## **Submission: Bango Wind Farm EIS**

### **Introduction**

Figure 5: Visual magnitude levels for VIA

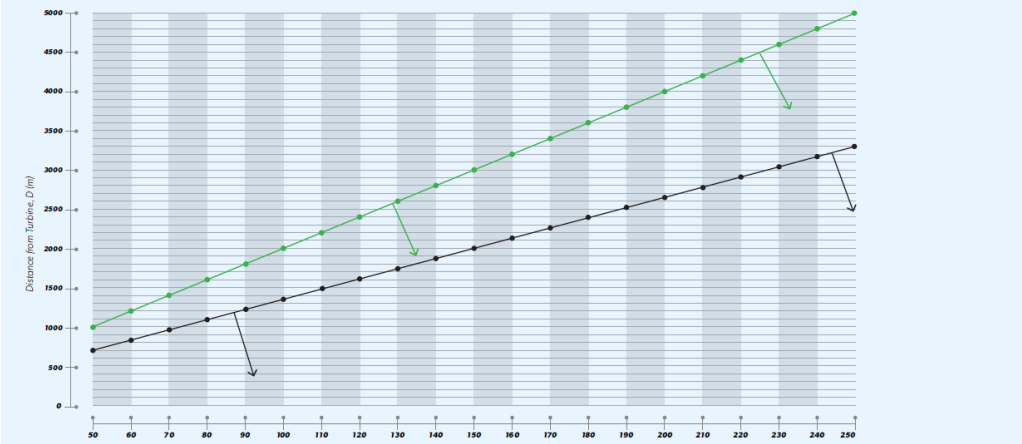
According to Figure 5 in the VIAB (reproduced below), ‘moderate’ landscapes require detailed justification for 200m turbines that are located closer than 2.65km and for 160m turbines that are located closer than 2.12km to a residence. Yet Residence 282 is only 1711m away from the nearest proposed turbine for layout 1 and is even closer for layout 2 (1653m), with turbines proposed to be up to 200m in height. There has been no justification provided for why this close proximity is deemed acceptable.
